Informal meeting on Code of Practice for Packing of Cargo Transport Units

Bedding arrangements

Submitted by IUMI and Maritem AB

This document proposes guidance on bedding arrangements to be included in clause 3.1.2 of Annex 7. The text proposed below should replace the existing text under that clause.

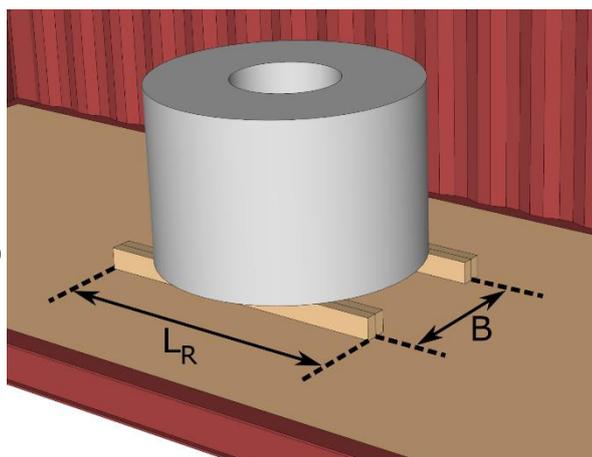
3.1.2.1 Step 1 – Determination of minimum length

The bedding beams must be long enough to cover the distance of the container’s floor so that load from the cargo will not overstress the floor.

The minimum length depends on the following factors:

- The cargo mass (in ton)
- The distance between the beams, B (in meters)

Table X.1 gives the minimum required length, L_R , of longitudinal bedding beams based on these two factors.

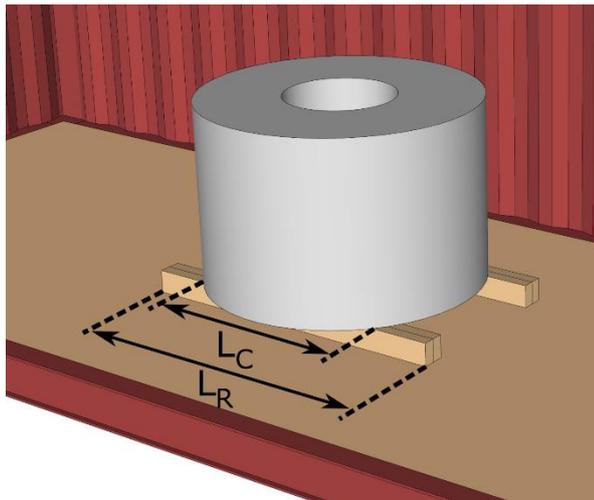
The proper size of the bedding beams depends on the bending resistance (section modulus) that is required of the beams for them to successfully transfer the load from the cargo over the required floor length. The required section modulus depends on the following factors:

- The cargo mass (in ton)
- The minimum length of the beams, L_R (in meters), as given by Table X.1
- The length of the footprint of the cargo on the beams, L_C (in meters)
- The strength of the material of the bending beams

The difference between the length of the beams, L_R , and the length of the cargo footprint, L_C , is denominated as the free length.
